# UNITED STATES PATENT AND TRADEMARK OFFICE

APPLICATION NO.	FILING DATE	FIRST NAMED INVENTOR	ATTORNEY DOCKET NO.	CONFIRMATION NO.
10/771,287	02/05/2004	Tomomi Endo	03327.2319	1144
7590 08/10/2004			EXAMINER	
Finnegan, Henderson, Farabow, Garrett & Dunner, L.L.P. 1300 I Street, N.W. Washington, DC 20005-3315			LE, THANH TAM T	
			ART UNIT	PAPER NUMBER
			2839

<b>Office Action Summary</b>	Application No. 10/771,287	Applicant(s) ENDO ET AL.	
	Examiner Thanh-Tam T. Le	Art Unit 2839

## DETAILED ACTION

Fig. 4

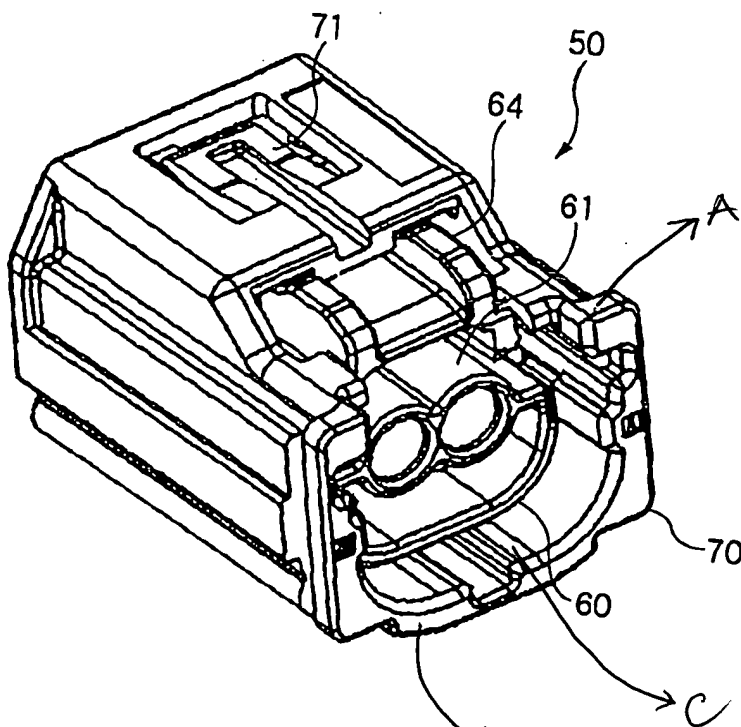
3. Figures 4 and 5 should be designated by a legend such as --Prior Art-- because only that which is old is illustrated. See MPEP § 608.02(g). Corrected drawings in compliance with 37 CFR 1.121(d) are required in reply to the Office action to avoid abandonment of the application. The replacement sheet(s) should be labeled "Replacement Sheet" in the page header (as per 37 CFR 1.121(d)) so as not to obstruct any portion of the drawing figures. If the changes are not accepted by the examiner, the applicant will be notified and informed of any required corrective action in the next Office action. The objection to the drawings will not be held in abeyance.

6. Claims 1-5 are rejected under 35 U.S.C. 102(b) as being anticipated by Applicant's prior art (figures 4 and 5).

Applicant's prior art, figures 4 and 5, discloses a connector comprising:

- a first connector housing (60) provided with a flexible lock arm (64);
- a tubular fitting detector (70) fitted to an outer periphery of the first connector housing while being slidable thereon between a first position and a second position;

- a retainer (71) provided on the fitting detector, and adapted to be engaged with a first position of the lock arm in a case where the fitting detector is placed at the first position, and engaged with a second position of the lock arm in a case where the fitting detector is placed at the second position;

- a second connector housing provided with a projection adapted to release the engagement between the retainer and the first position of the lock arm in a case where the second connector housing is completely fitted with the first connector housing, so that the fitting detector is allowed to slide from the first position to the second position; and

- a finger pad (A, see a figure below) provided on the fitting detector, and arranged such that an operator's finger is placeable thereon while being separated from at least the lock arm, during a fitting operation between the first connector housing and the second connector housing.

Regarding claim 2, an upper face of the finger pad on which the operator's finger is placed is situated upper than an upper face of the lock arm.

Regarding claim 3, the finger detector comprising a pair of side walls and a bridge member (B, see the figure below) connecting the side walls while preventing the operator's finger from being brought into contact with the first connector housing.

Regarding claim 4, the bridge member comprising a guide projection (C, see the figure below) which is usually brought into contact with the first connector housing.

Regarding claim 5, the guide projection is extended from the bridge member in a sliding direction of the fitting detector.
